CITY OF ALBUQUERQUE

RE: **Lot 5 Block 5 S.A.D. 227 Unit 5**
6508 Onyx NW
Grading and Drainage Plan
Engineers Stamp Date 11/6/19 (E10D069)

ENGINEER'S SEAL  11/6/19 DAVID SOULE P.E. #14522	LOT 5 BLOCK 5 UNSER CLIFFS SUB 6508 ONYX COURT N.W. GRADING AND DRAINAGE PLAN  Rio Grande Engineering 1608 CENTRAL AVENUE SE SUITE 201 ALBUQUERQUE, NM 87106 (505) 972-0899	DRAWN BY DEM
		DATE 11-5-19
		LOT 5 BLK 5 UNSER CLIFFS.DWG
		SHEET # C1
		JOB #

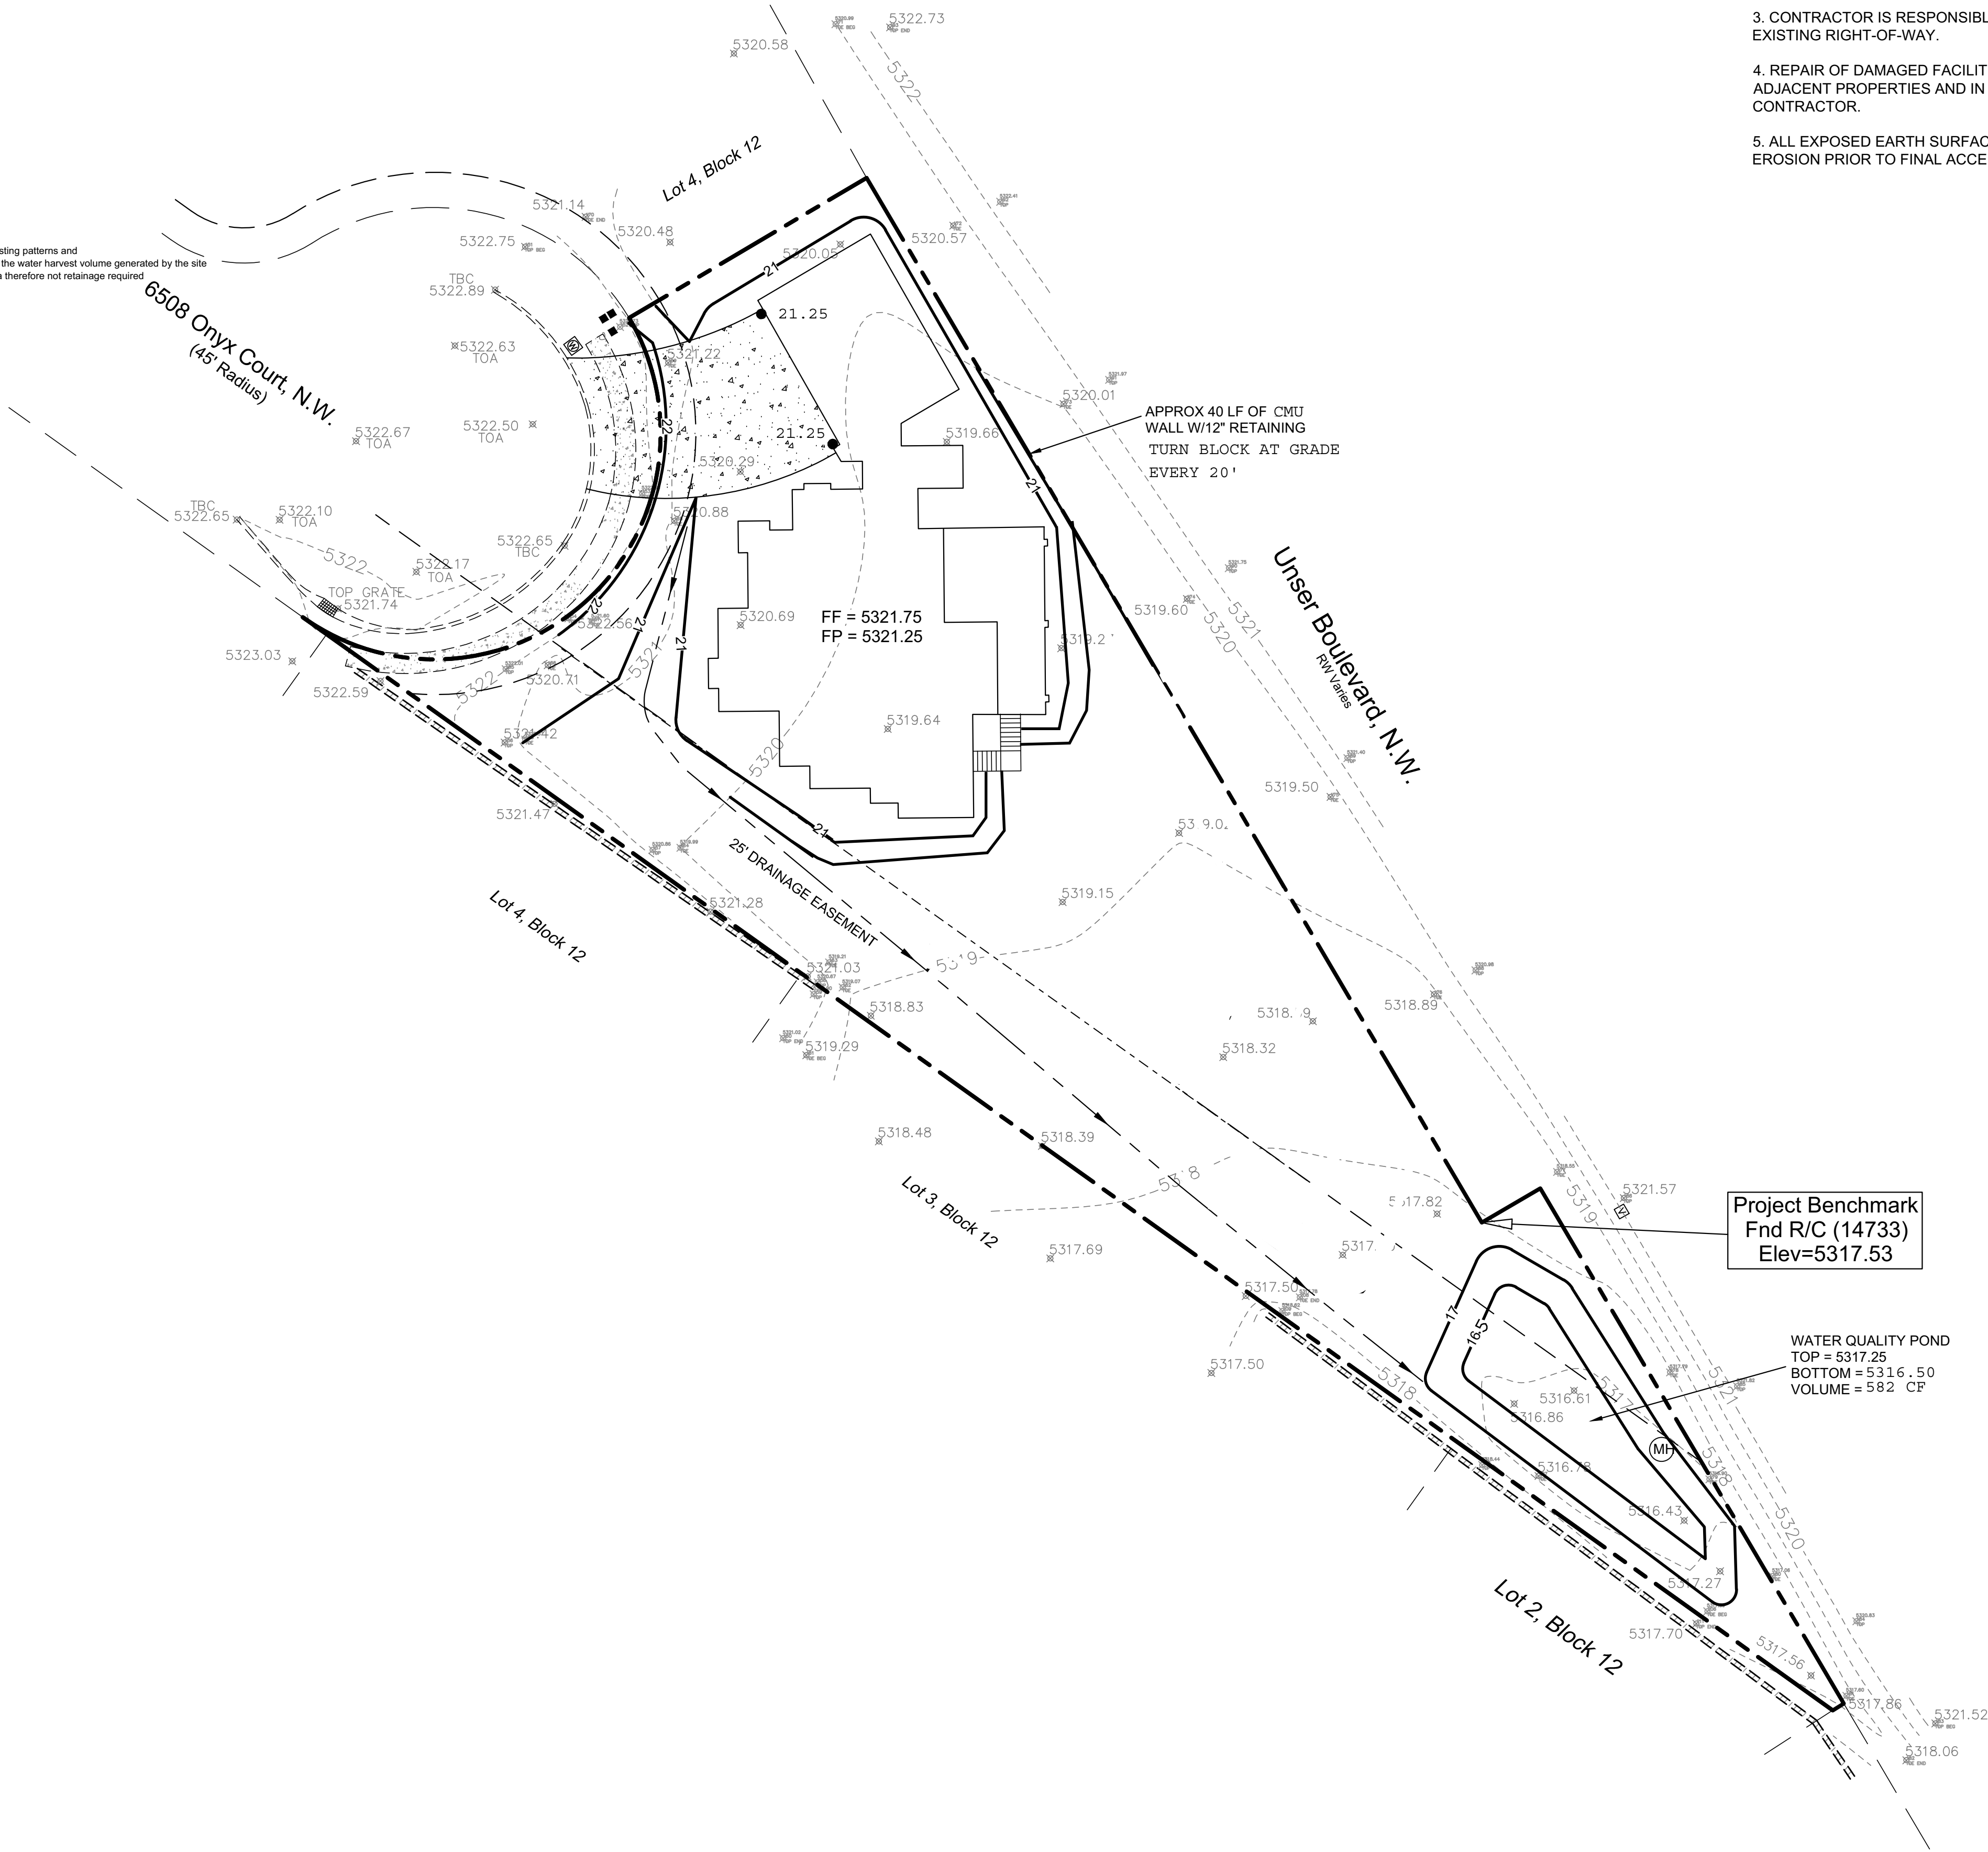
Based upon the information provided in your submittal received 11/7/19, this plan is approved for Grading Permit. Please inform the builder/owner to attach a copy of this approved plan and letter into the construction sets in the permitting process prior to sign-off by Hydrology.

Reiterate to the Owner/Contractor that a separate permit for any garden/retaining wall must be obtained, with the approved G&D plan.

Prior to Building Permit approval, a **Pad Certification** will be required. Inform the contractor/owner not to pile dirt in the street as a ramp to climb the curb. If dirt is found in the street the pad cert. will be denied.

Prior to **Certificate of Occupancy release**, Engineer Certification per the DPM checklist of this plan will be required.
